1/18/2023 | 6:00 PM

**MUNICIPAL SERVICES CENTER, COUNCIL CHAMBER
3600 TREMONT ROAD**

- a. Review of the November 16, 2022 BZAP minutes and January 4, 2023 BZAP Work Session minutes.
- b. 4462 Summit Ridge Drive (VAR-01-23) - To allow a front porch and addition to encroach up to 17.5 feet into the minimum 60-foot setback (unplatted) and to allow a side addition to encroach up to 13 feet into the 20-foot minimum setback.
- c. 3259 Kenyon Drive (VAR-03-23) - To allow a one-story addition to encroach 2'-6" into the 8-foot minimum side yard setback.
- d. 2797 Wellesley Drive (VAR-04-23) - To allow the construction of an attached pergola that encroaches up to 11'-3" into the minimum 33'-8" rear yard setback.

Proposed Elevations

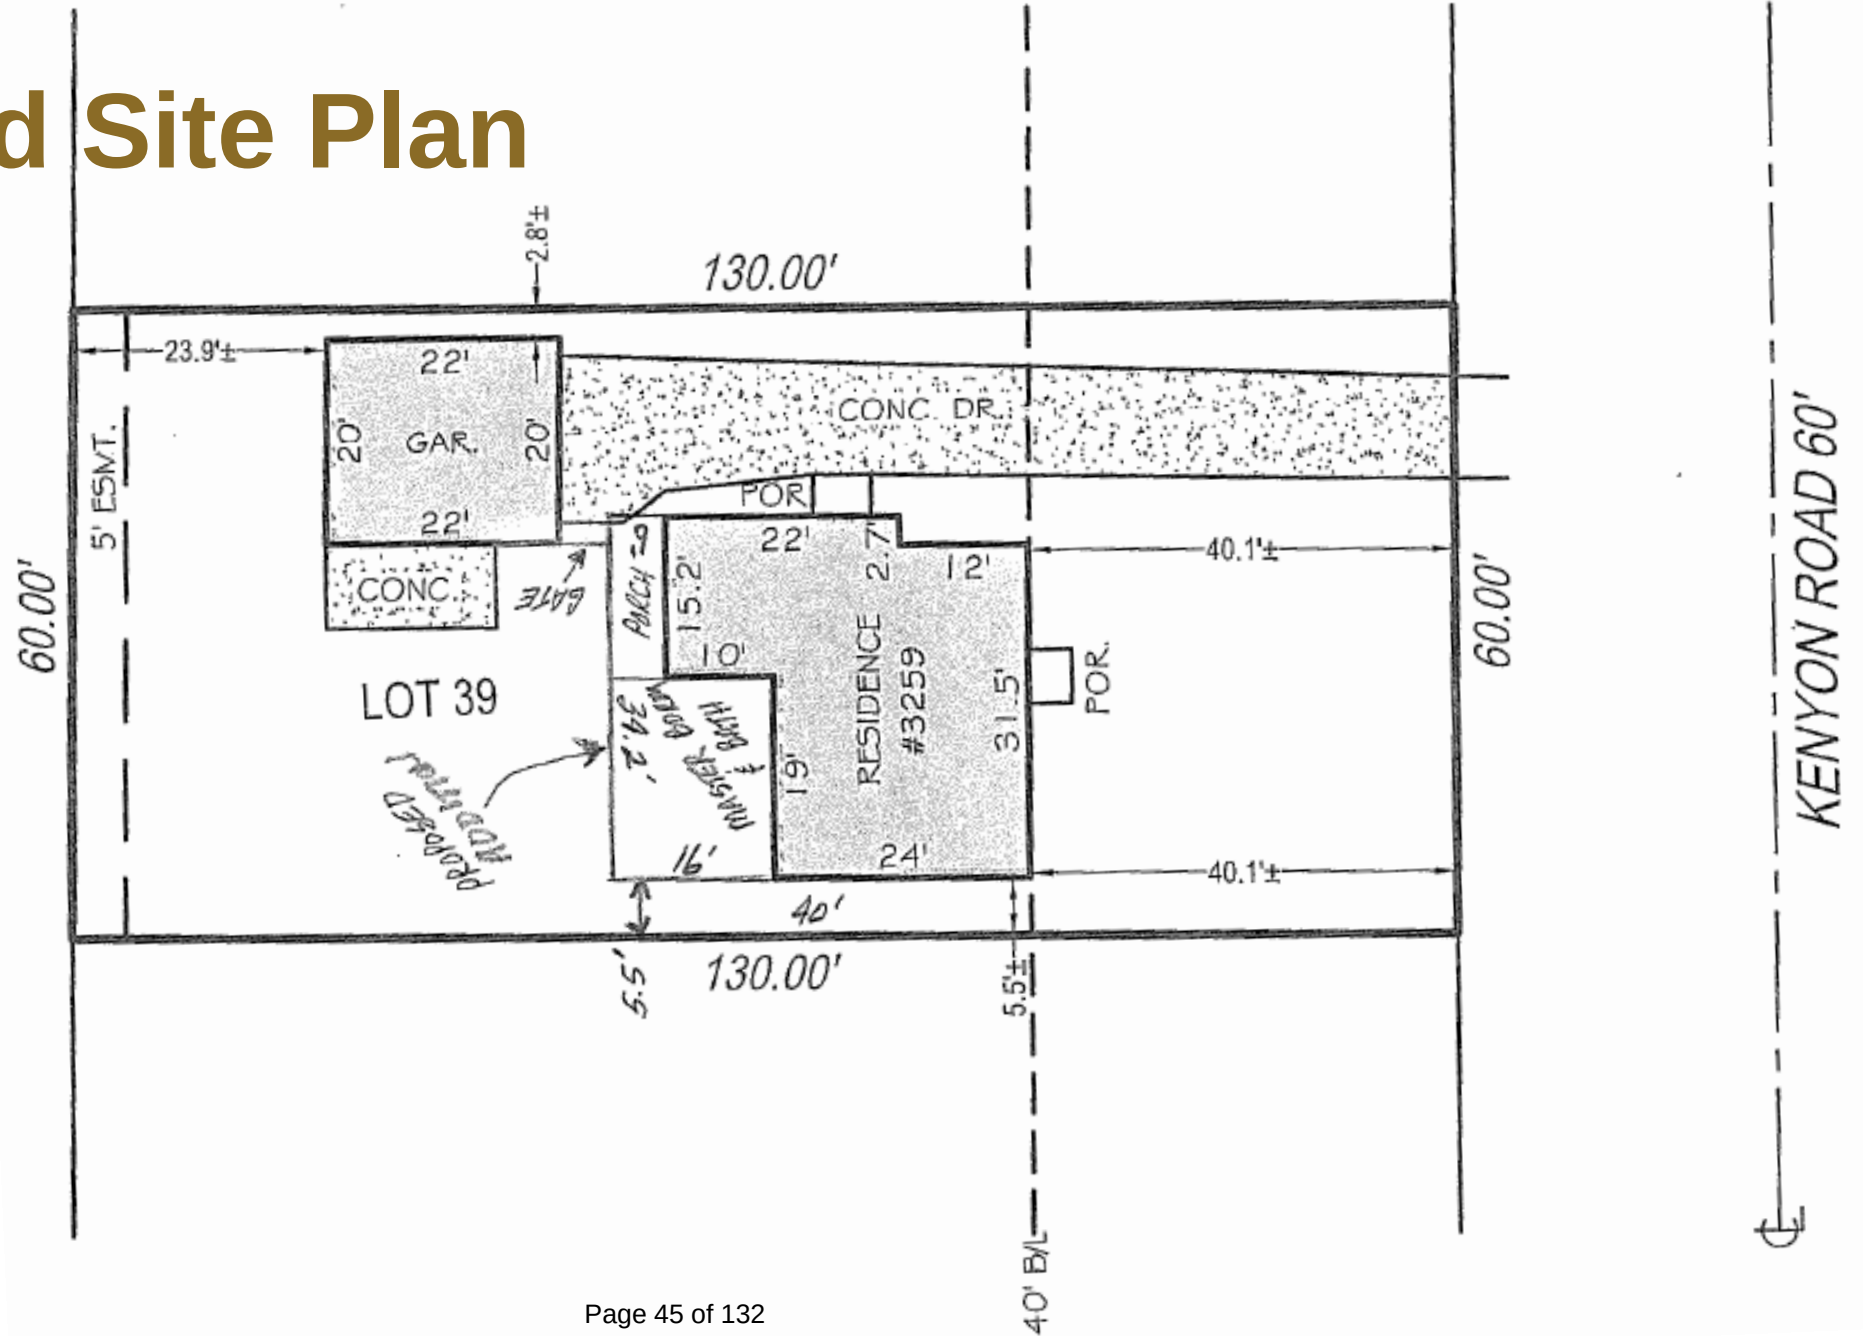
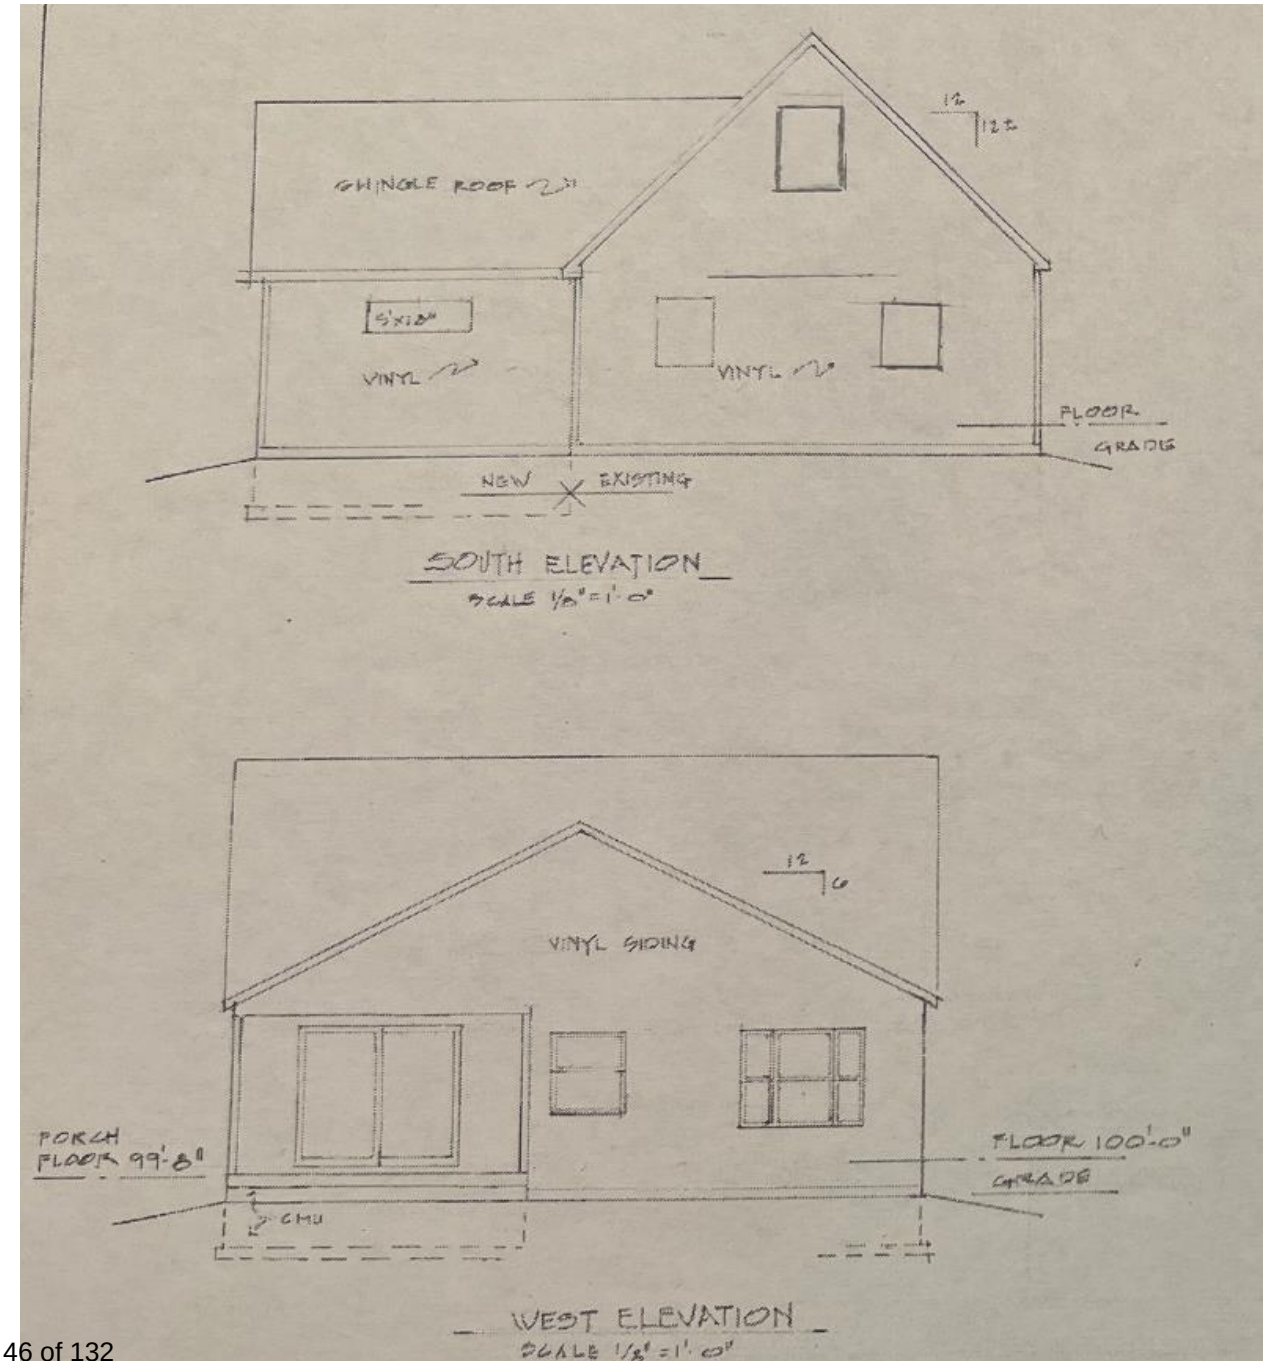
Staff has reviewed the application and plans, discussed it with the applicant, and visited the site. In this case, there is an existing/original encroachment over the side yard setback (Finding #6) and the proposed addition would extend this. The design and location of the addition seamlessly blends with the existing home and the location of windows will help ensure privacy for the adjacent neighbor (Finding #4).

Existing and Proposed Elevation

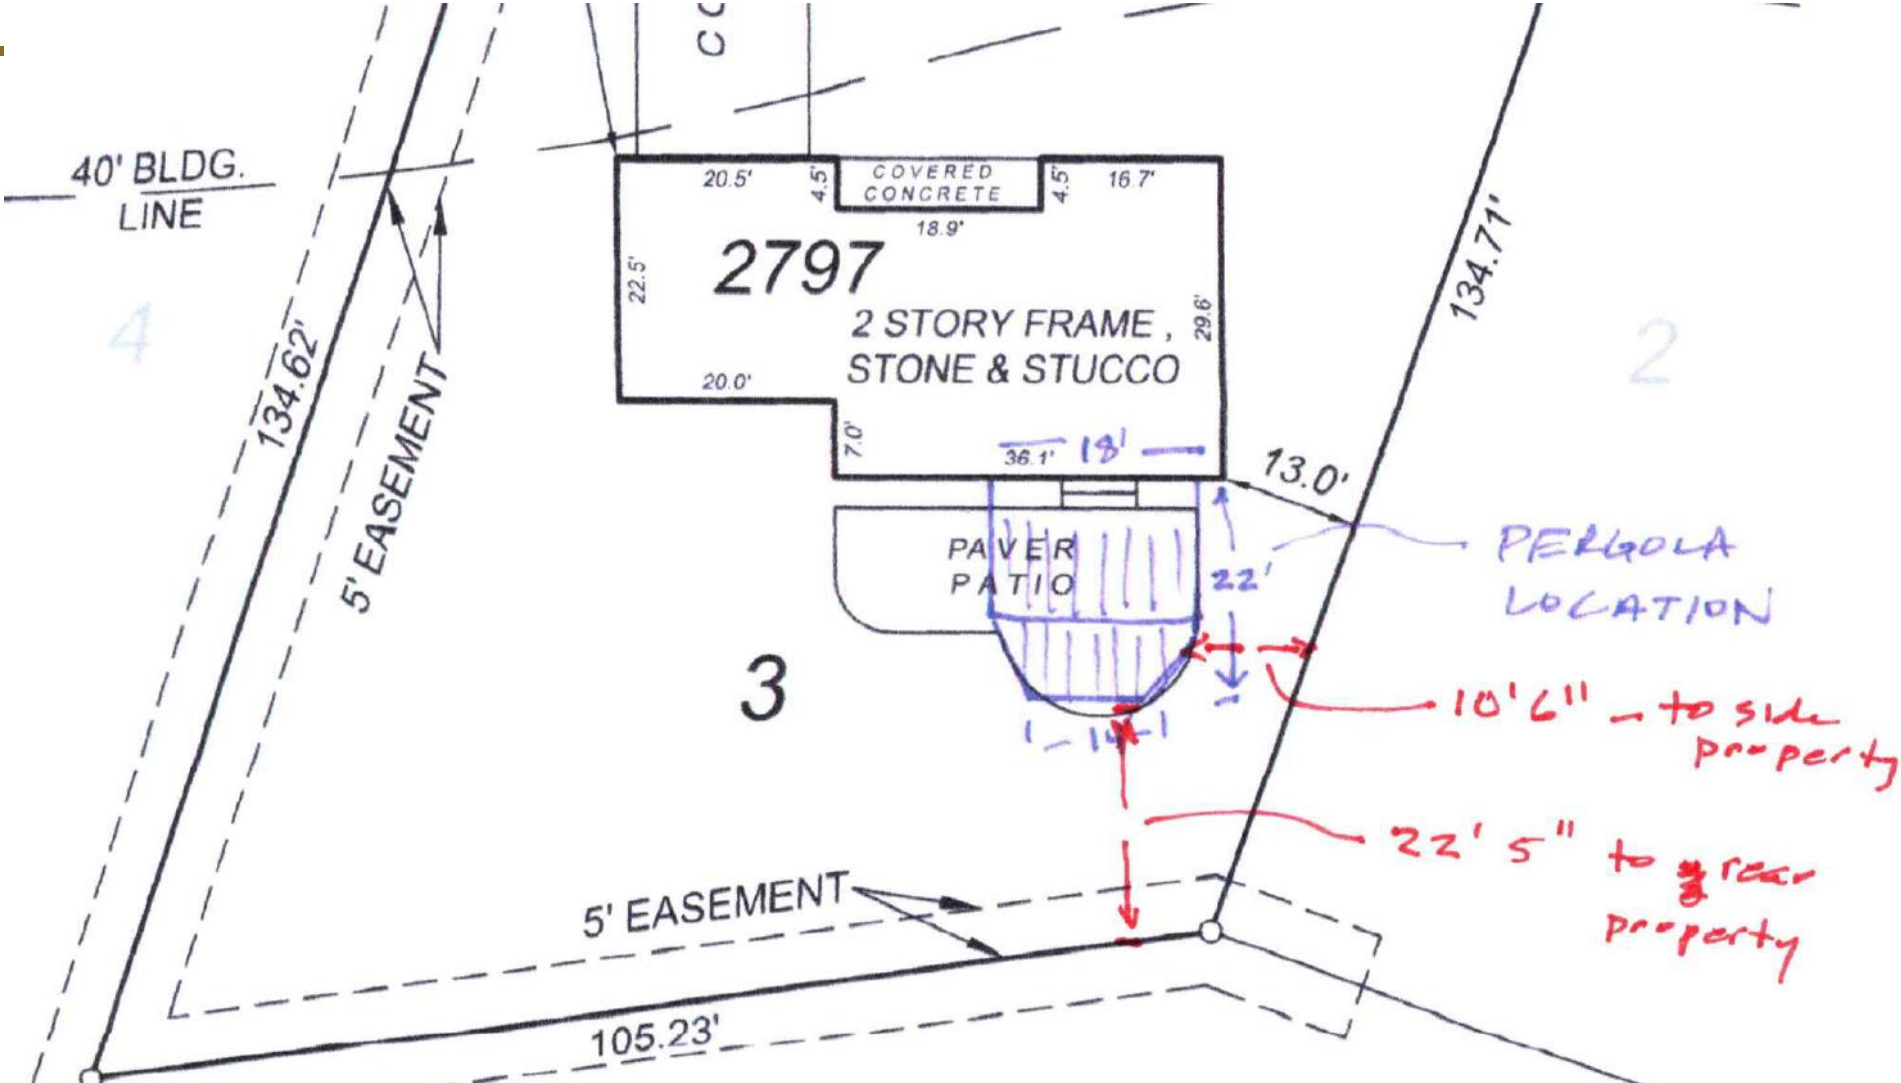
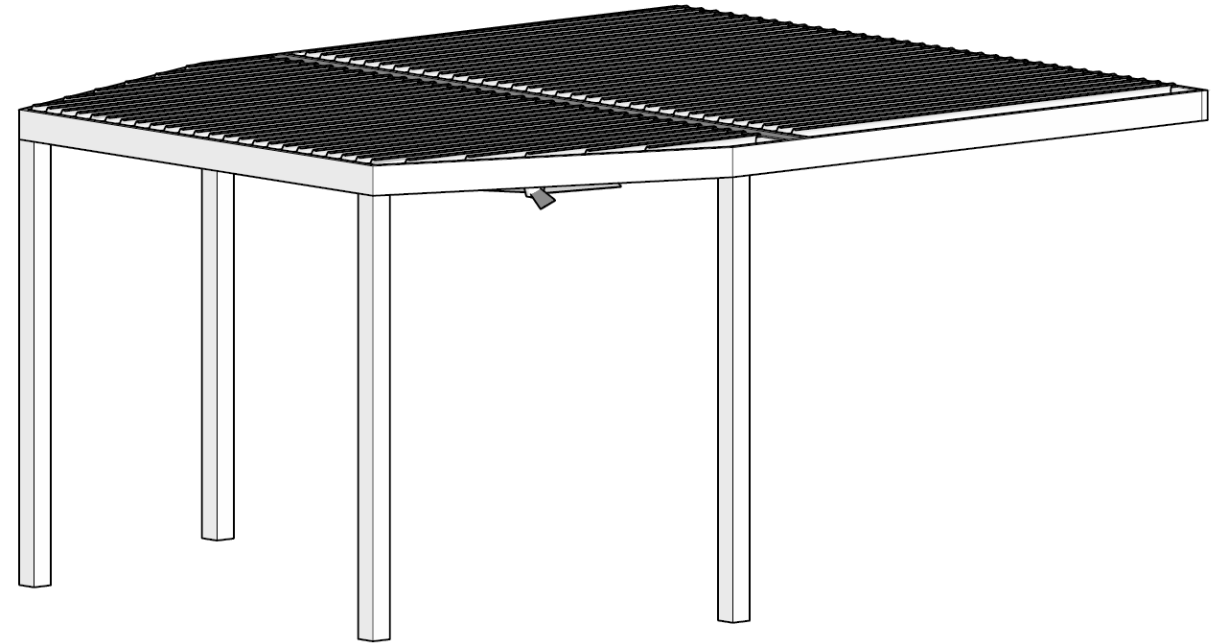
Staff has reviewed the application and plans, discussed it with the applicant, and visited the site. Although the proposal is for a large covered porch, Staff has found the orientation of the lot and position of the home behind the front yard setback limit additions to the rear of the home (Finding #6). The design and style of the porch will minimize potential looming impacts on neighbors and the existing six-foot tall fence provides privacy (Finding #4). If the pergola was detached from the home and the roof remained open, it would be permitted without a variance, but this appears to be a better solution both structurally and long-term.

Proposed/Existing Elevation

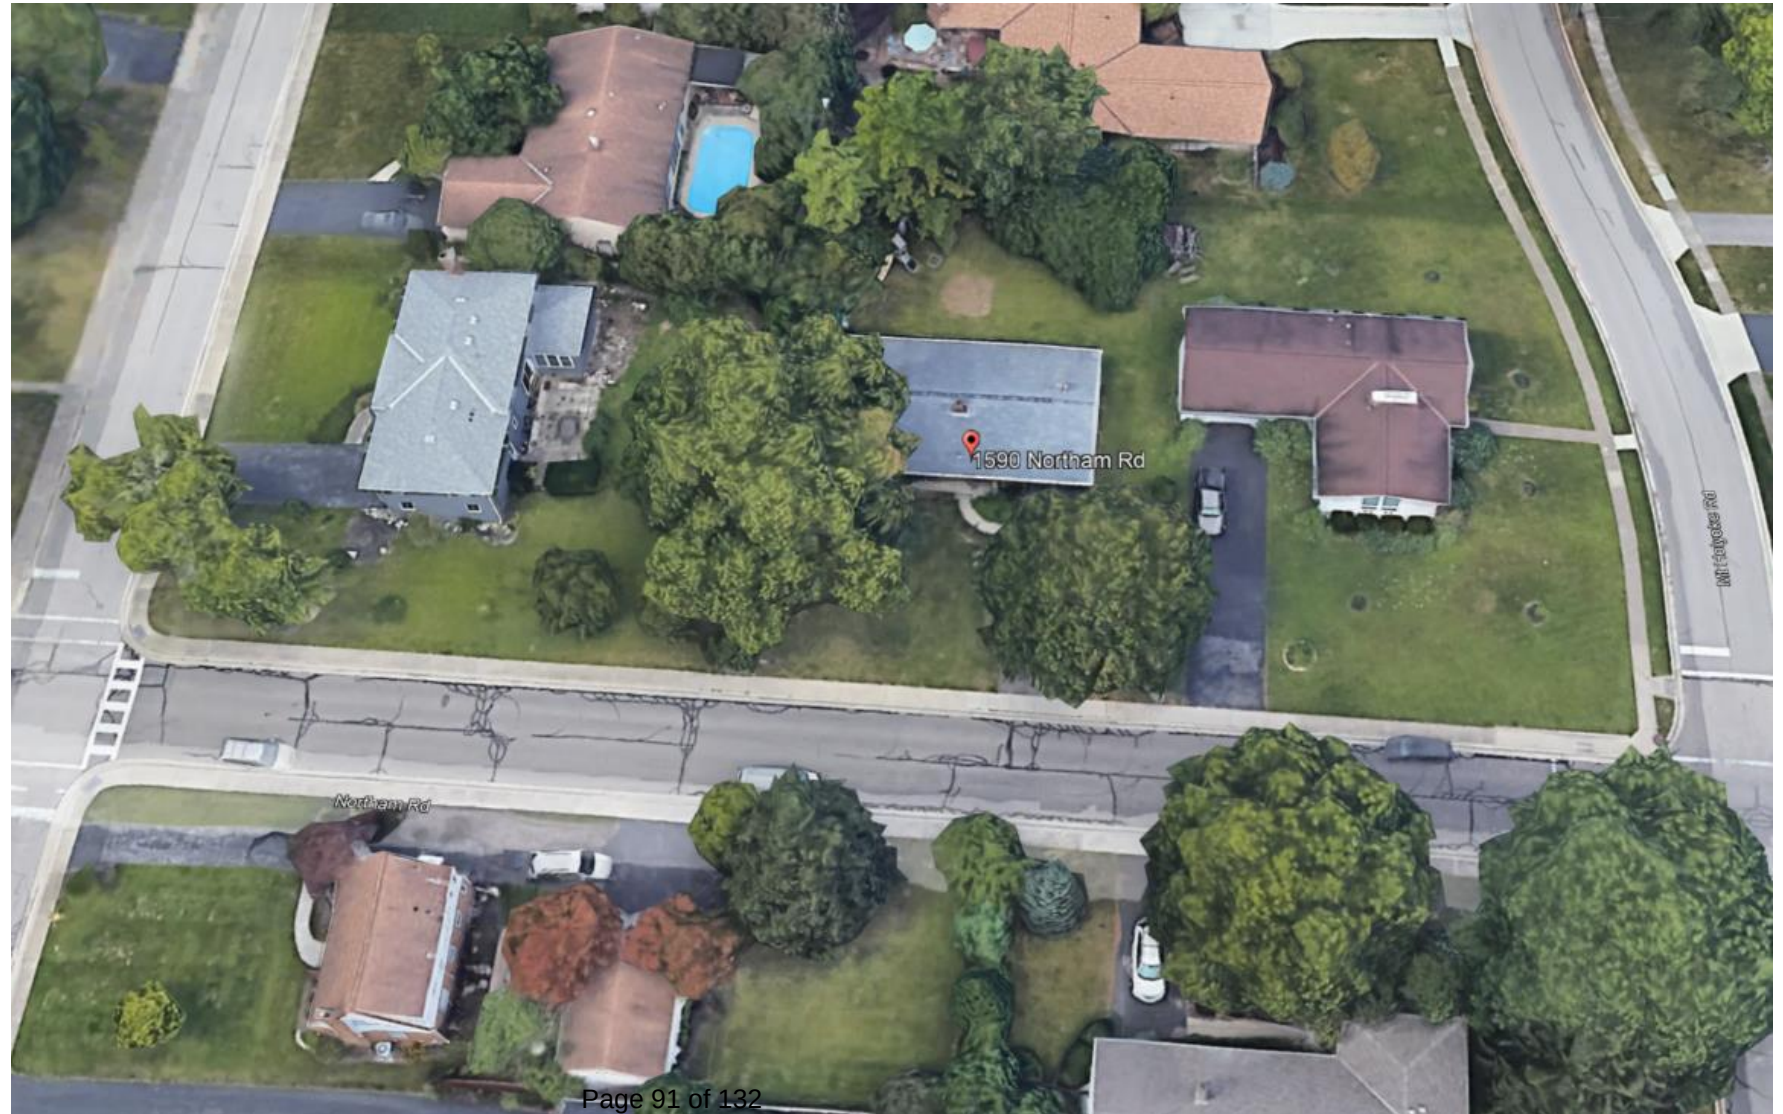
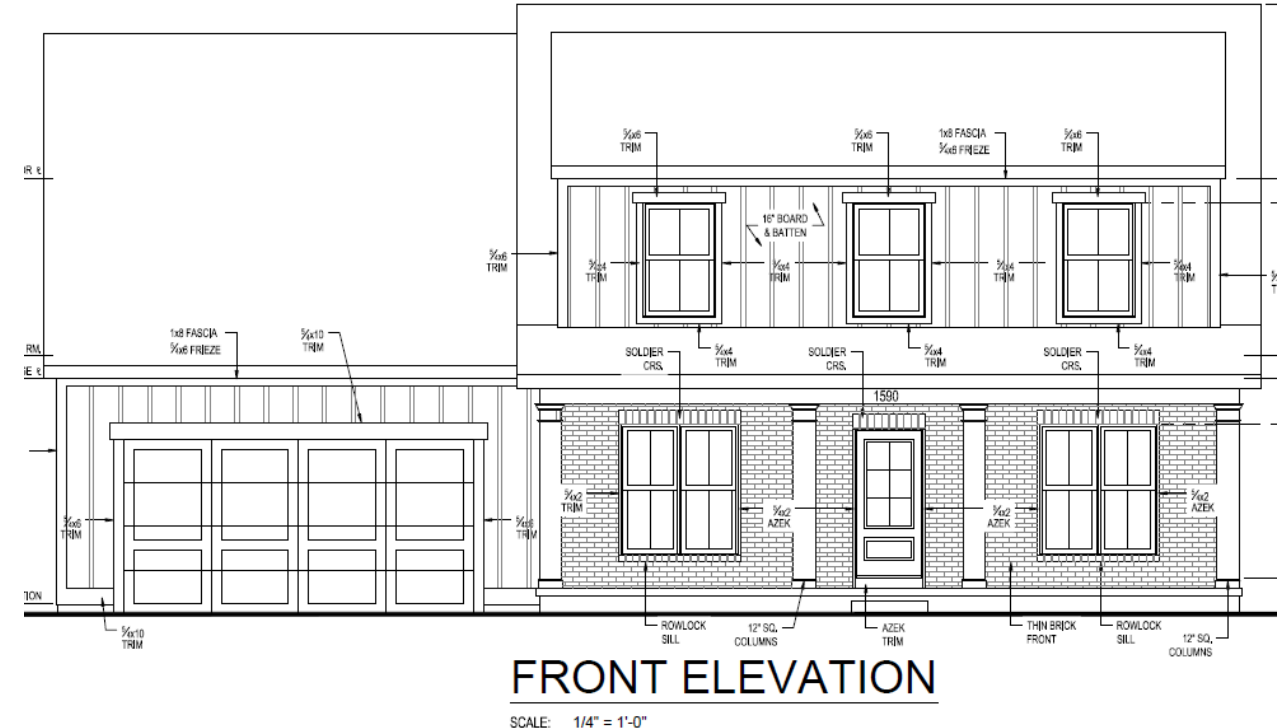
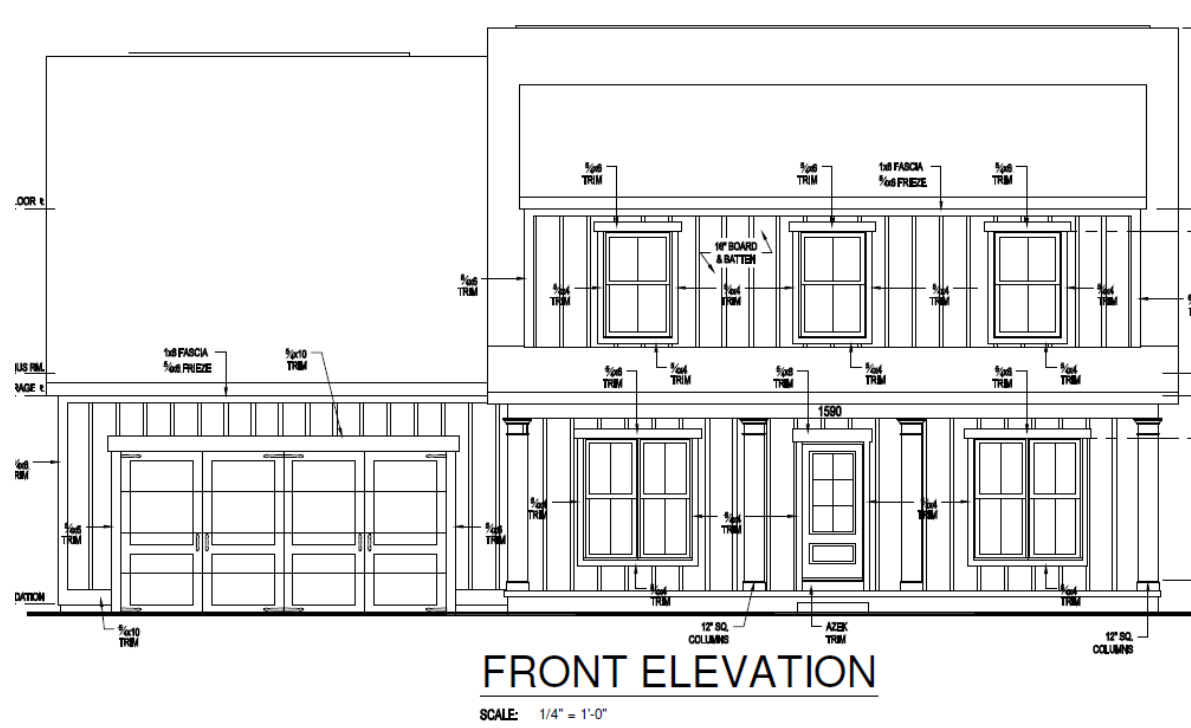
The variance request includes a revised front elevation for the proposed new home that removes all brick from the exterior façade. Instead, the front façade would include Board and Batten siding, while the sides would include a mix of Board and Batten and Hardi Plank siding; the rear would include only Hardi Plank siding. All other design features would remain from the approved Building Permit.

For these reasons, Staff cannot support the variance request at this time and would note Findings #2 and #7 for the Board to consider.
